UPDATE REPORT

Application No.: 181421/FUL

Address: Royal Court, Kings Road

Proposal: Amended description: Reconfiguration of the disused restaurant space to include a café (Class A1) with an external seating area, and creation of 3 (2x studio & 1x1-bed) residential units (Class C3) at lower ground floor level and associated works.

Figure 1 - Typical section of proposed canal side balcony

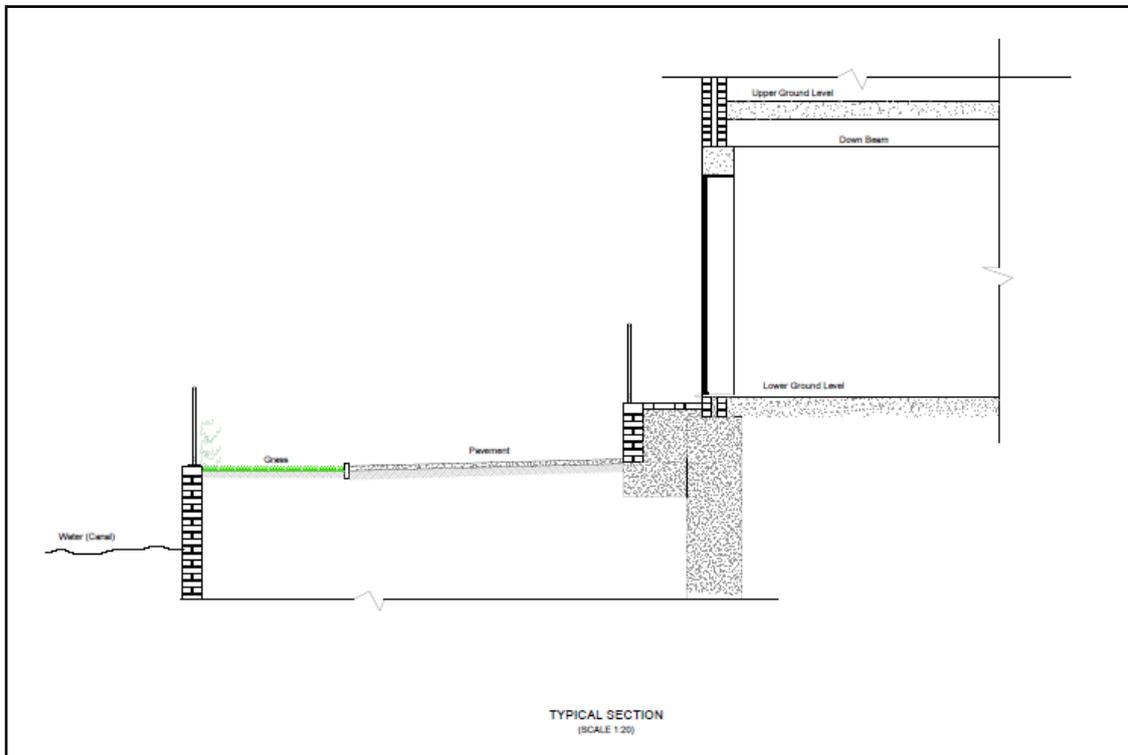
- 2.1 As outlined in the original report, a proposed typical section plan has been requested from the agent to demonstrate the relationship of the proposed flats to the canalside pedestrian area. On 26 February, the agent provided the following additional plan:
